Howse Property Iron Mine Project Information Request (CEAA 106)

Context and Rationale: The Canadian Environmental Assessment Agency (the Agency), with input from NRCan, has conducted a technical review of the proponent's responses to Information Requests (IRs) CEAA 16 to 20 (Round 1, Part 1). NRCan has noted some errors and issues in SNC's Report titled *Hydrogeology Numerical Modeling for the Howse Deposit Project*, dated May 16, 2017 (SNC May 2017). The Agency's internal review has identified two further issues that must be addressed before the Agency can accept the response as adequate.

Figure 1

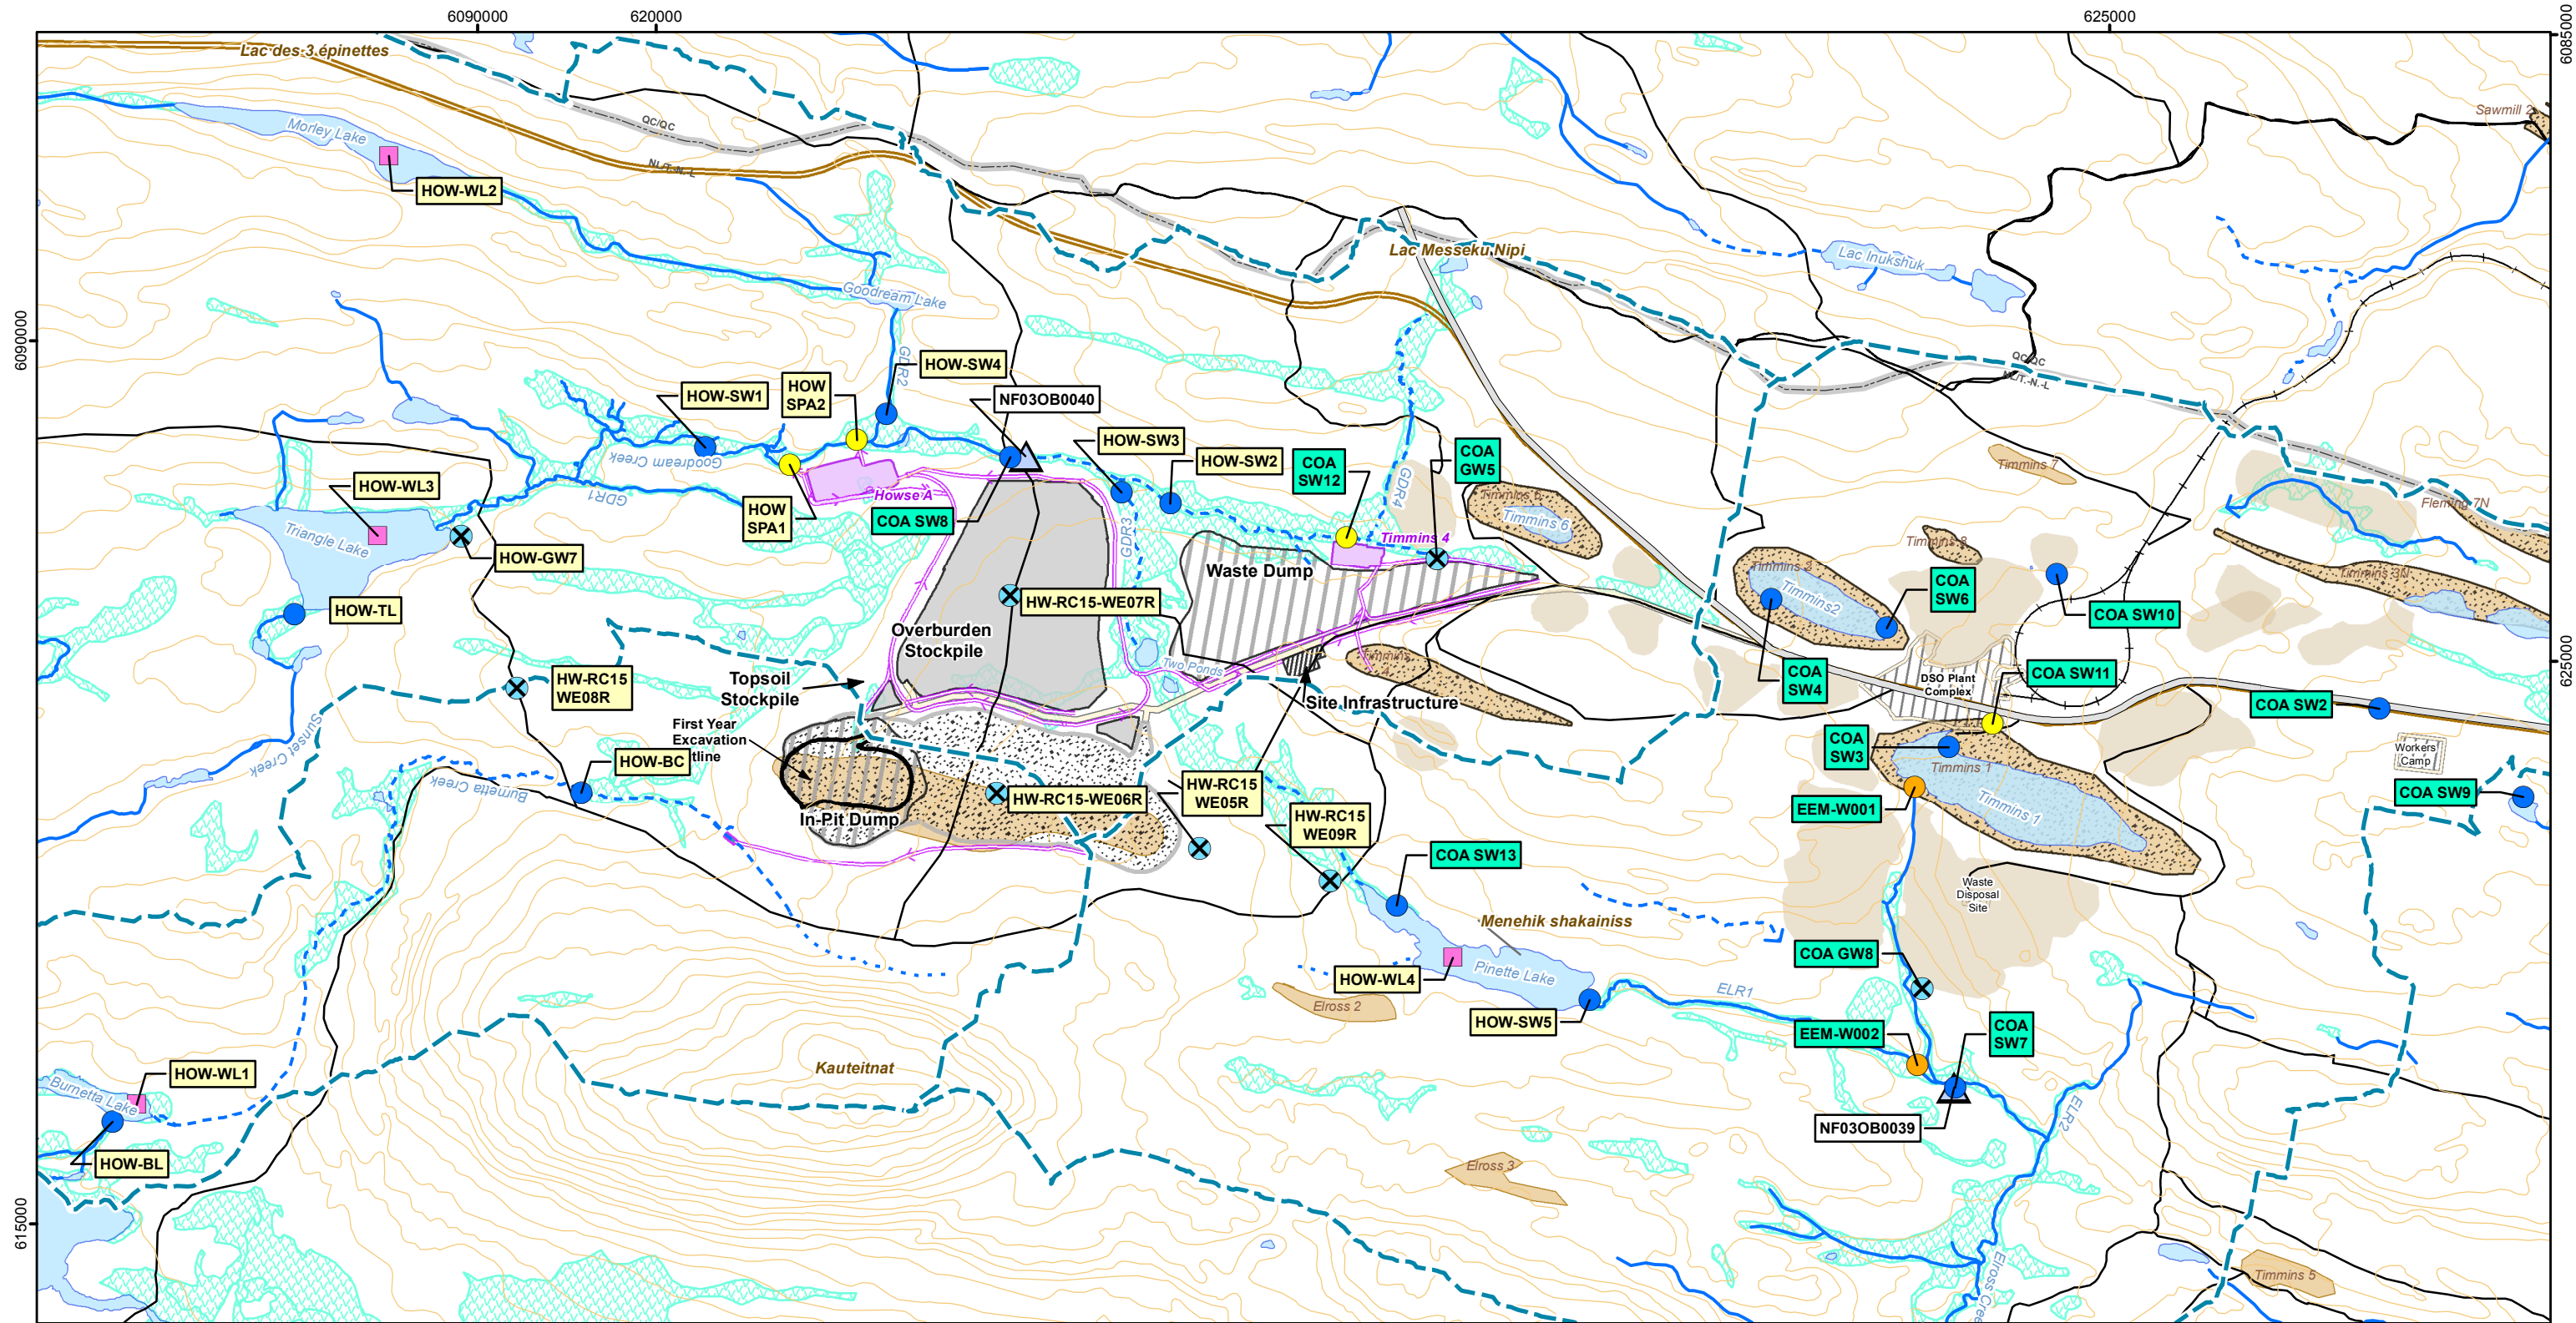
2. In the May 30, 2017 memo submitted to the Agency, the proponent describes monitoring and follow-up measures at Triangle Lake, Morley Lake, and Goodream Creek. Based on *Figure 1: Water Monitoring Plan* (submitted to the Agency on April 26, 2017 - see attachment), the SNC May 2017 report, and the EIS, the Agency understands the proponent would also monitor surface water and groundwater quality and/or quantity at various other points around the Project, including Pinette Lake, Burnetta Lake, local wetlands, and at other locations.

Update *Figure 1: Water Monitoring Plan* as appropriate, and provide an overview of the water quality and quantity parameters that would be monitored at all water monitoring stations which would be part of the Project's follow-up program.

Water quality will be monitored through several means. First, GNL's RTWQ Monitoring Network already has Instant Water Monitoring Stations in Goodream Creek and Elross Creek. These stations supply live information on water levels plus a number of water quality parameters. Other stations could be installed in the LSA at the GNL's request. The Howse Project is also subject to the *Environmental Control Water and Sewage Regulations, 2003* (Newfoundland and Labrador Regulation 65/03), under the *Water Resources Act* (O.C. 2003-231). The Howse mine is subject to the *Metal Mining Effluent Regulations* (SOR/2002-222), under the *Fisheries Act* (R.S.C., 1985, c. F-14); the monitoring program already in place for TSMC's DSO projects, including monitoring for physico-chemical parameters, will be extended to include the Howse Project. The combination of these programs will ensure proper monitoring of water quality during mine operation.

Parameters will follow MMER. Please refer to section 9.1.3 of the Howse EIS for more details. For groundwater, water level and quality (following MMER guidelines) will be recorded four times annually for the duration of the construction, operations, and decommissioning phases

Parameters will follow MMER and continuous flow. Please refer to section 9.1.5 of the Howse EIS for more details.

The lake levels will be monitored (cm) before (2017), during and after the operations phase. An automatic gauge will allow for hourly readings of water levels to be taken during the operations phase, and four times per year during the construction and decommissioning phases.

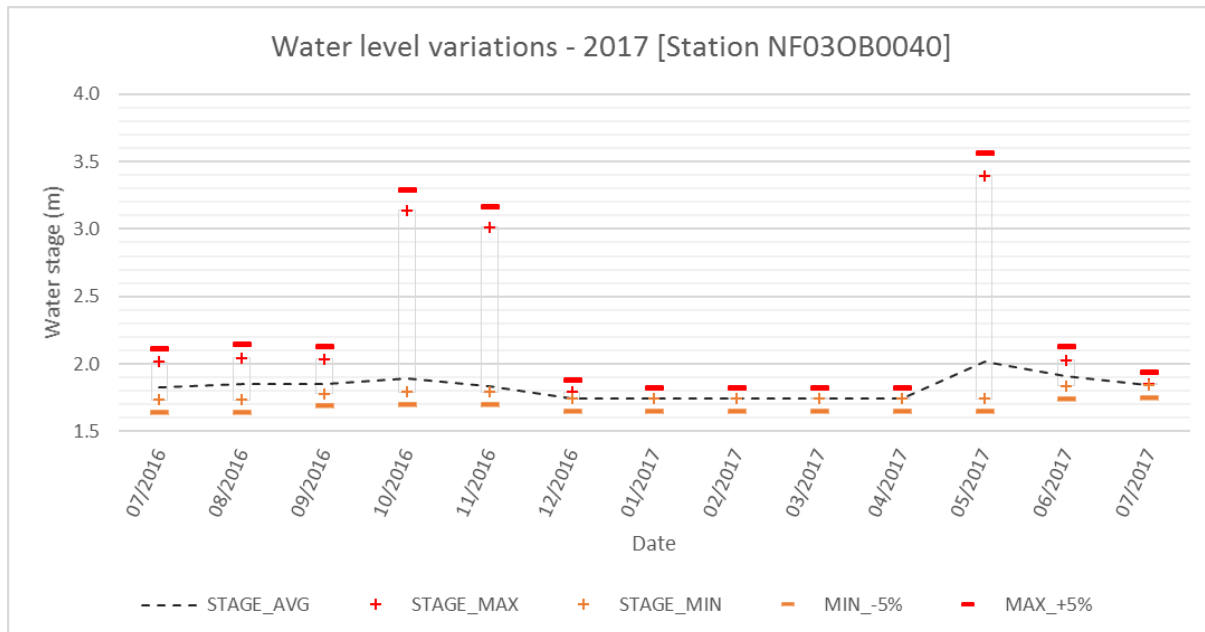
3. In conjunction with the request above, provide a description of the thresholds that monitoring results would be compared to or the other factors that would trigger the implementation of adaptive management actions or mitigation measures for affected waterbodies and wetlands.

Thresholds for water level should be considered both for groundwater and for surface water. As part of the hydrogeological numerical modeling, the consultant assumes that dewatering will induce aquifer drawdowns. Even though those drawdowns have been theoretically assessed, it is recommended to follow the recommendation of the consultant (implement an adequate groundwater monitoring). Whether the predicted groundwater levels should vary from more than $\pm 5\%$ (conservative variation), the theoretical drawdowns should be reviewed and corrective actions should be implemented.

Surface water naturally varies over the year. The average variations from the average stages in 2007 are -3.17% [min] and +18.30% [max]. Following the recent surveys conducted on site, it appears that there is no link between surface water and groundwater. Therefore, dewatering should not have adverse impacts on surface water stage. However, it is recommended to closely monitor water levels on the four lakes equipped with water gauges. The eventual observed variations should then be compared with water levels in station NF03OB0040. If the monitored variations exceeded $\pm 5\%$ of the minimum and maximum average stage, corrective actions should be implemented. As an example, the thresholds are represented as MIN_-5% and MAX_+5% in the following graph.

A conservative variation value of 5% is recommended at least for the 3 first years of operation (time to have enough data). This value could be reviewed to a normal value of 10% after 3 years.
